Access Compliance Report

Public Rights-of-Way

(Curb Ramps)

Intersection ID: 29371	Main Street: PLEASANT DALE DR	Cross Street: WILSON GLEN DR	Location: SW
ADA ID: 9361074F3FD5	Ramp Type: PerpDiag	Initial Pass/Fail: Pass	Overall Compliance: No
		Severity Score: 12.5

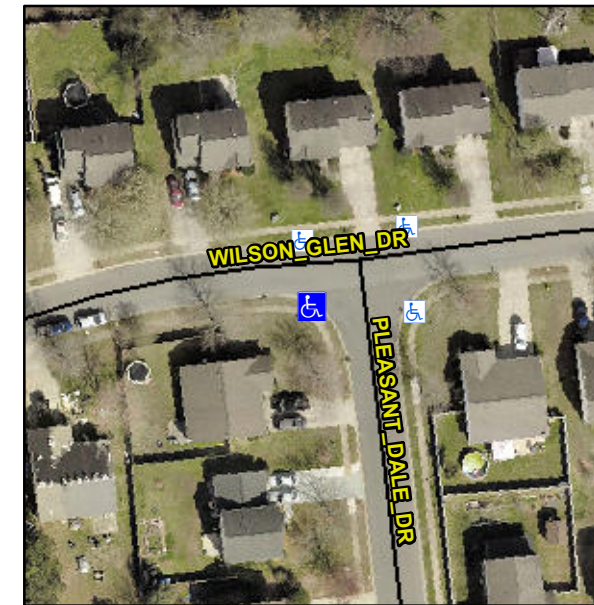
Not Found, R304.2.1, R304.2.2-Perp, R304.3.2-Para, R304.5.3, R305.1.4

Remove & Replace Curb Ramp With Two New Directional Ramps or Equivalent.
